13. The Multiple Spanning Tree Protocol (MSTP)

Figure 13-6—Example Network with CIST Priority Vectors, Port Roles, and MST Regions

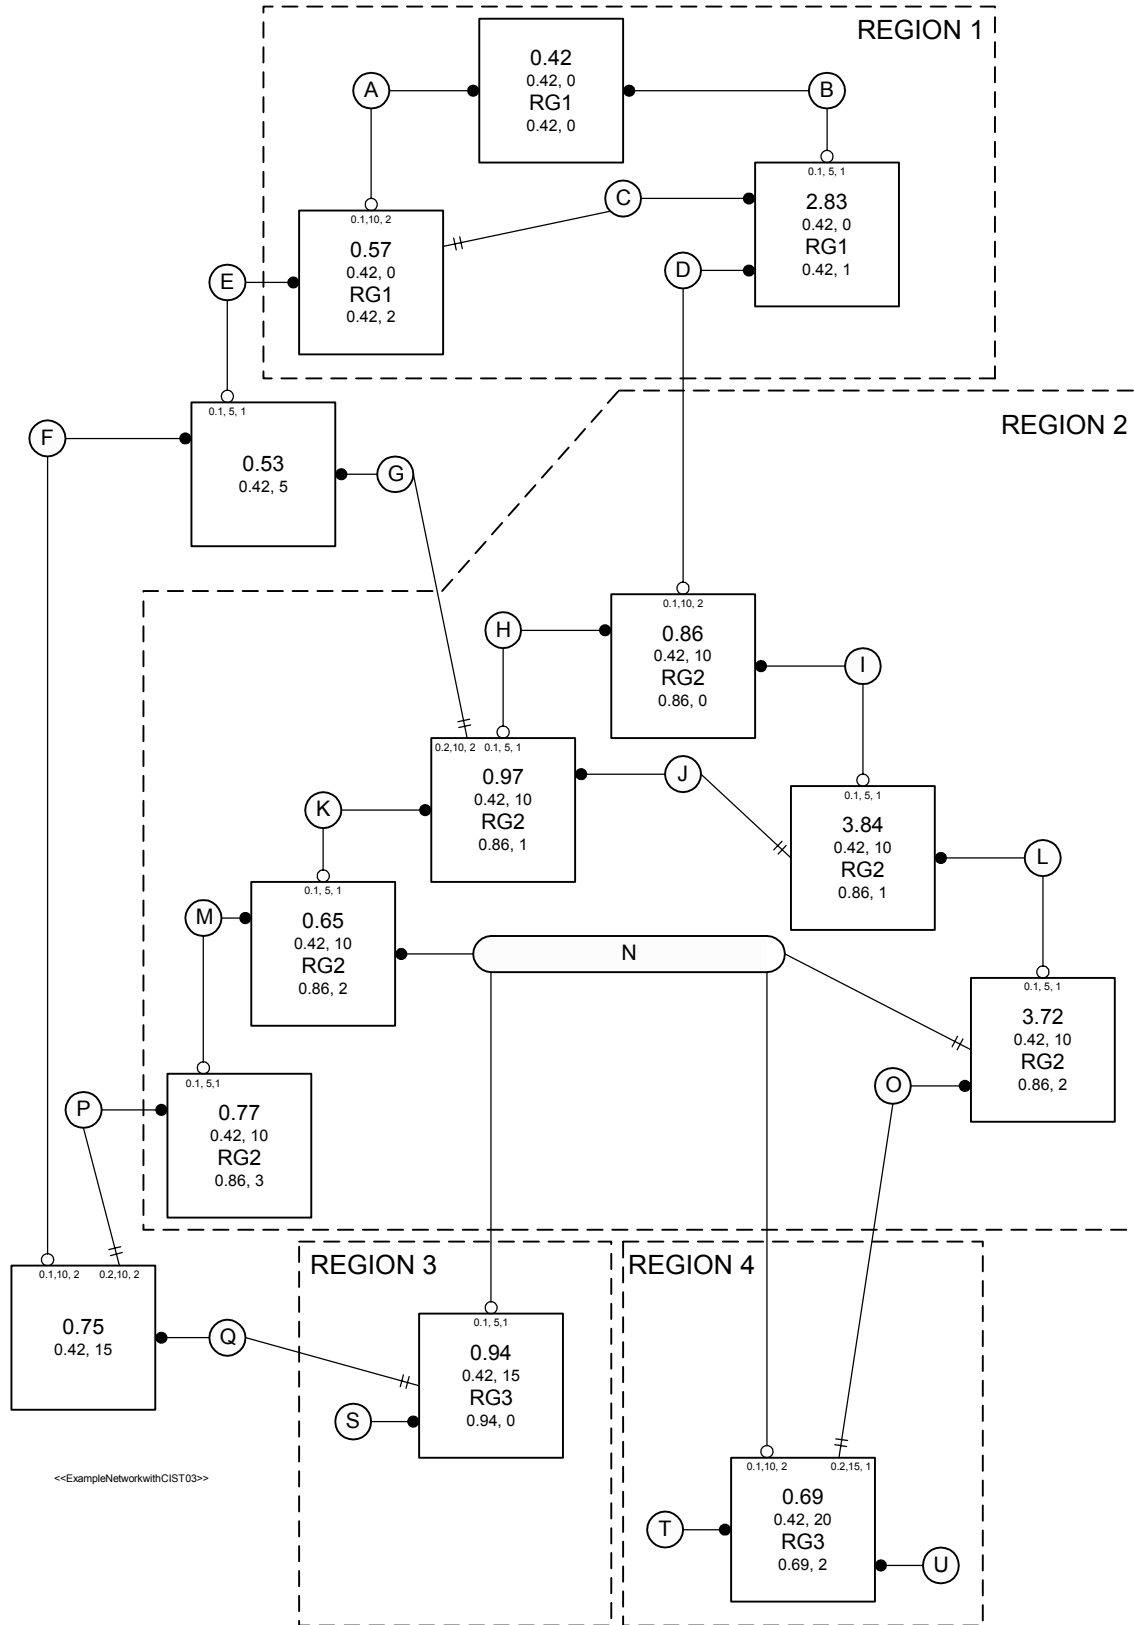
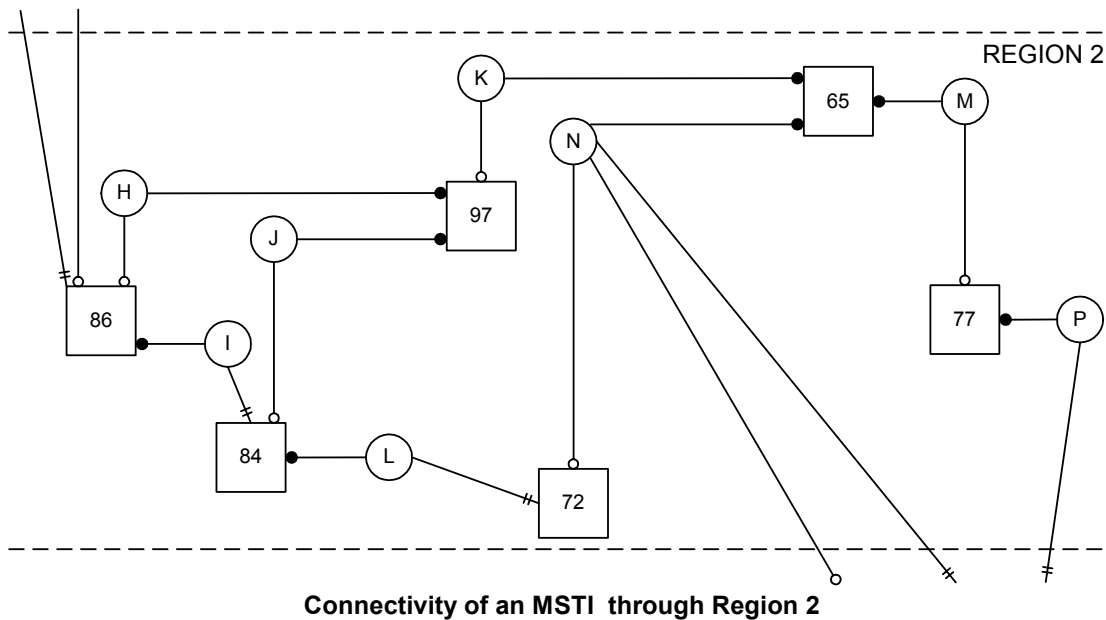
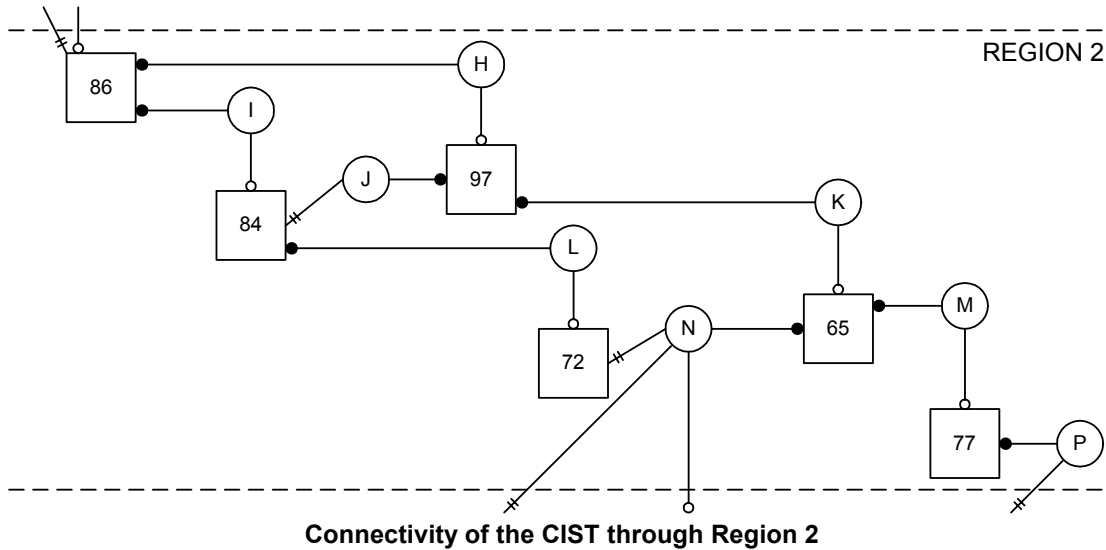
b) Why is the Alternate Port on bridge 97 on Figure 13-6 moved to bridge 86 on Figure 13-14?>>

Figure 13-8—MSTI Active Topology in Region 2 of the example network

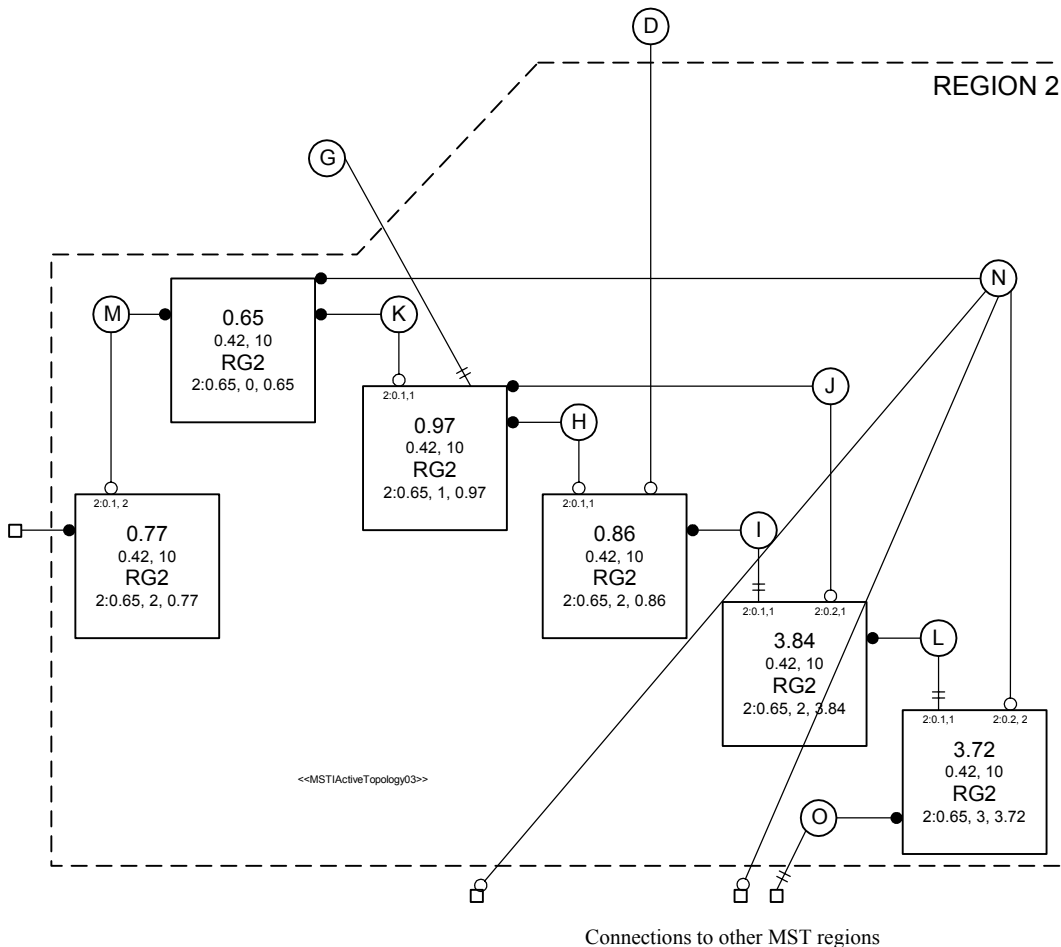
a) The Internal Root Path Cost for MSTID 2 on MST bridge 3.72 (bottom right hand corner of Figure 13-8) indicates 3: it should be 2 instead as connectivity to the MSTI Regional Root is provided by port 0.2 w/ a cost of 2?

Figure 13-18—MSTP state machines—overview and relationships

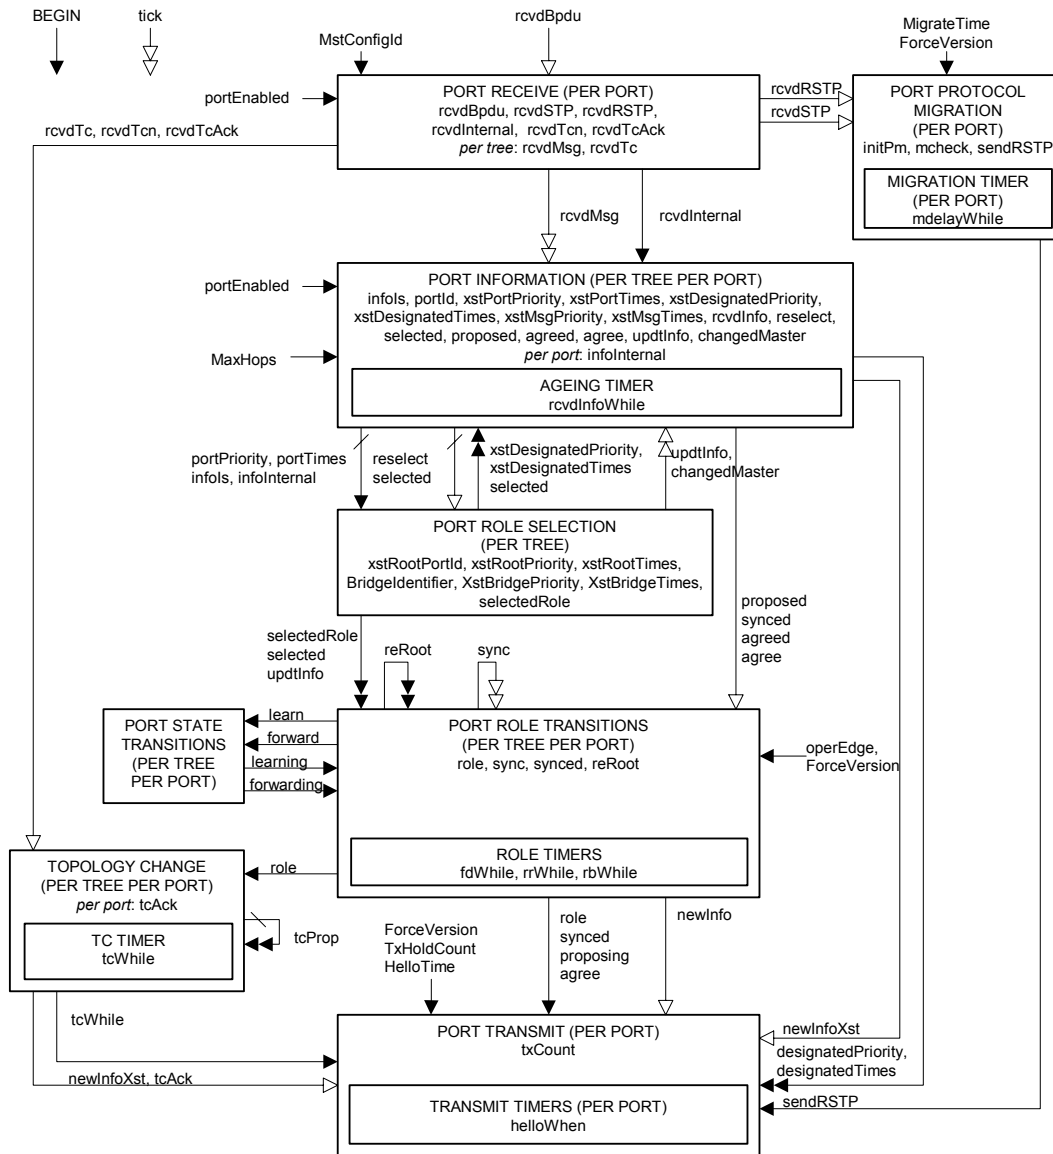
<< Editor's note: following diagram to be updated. >>
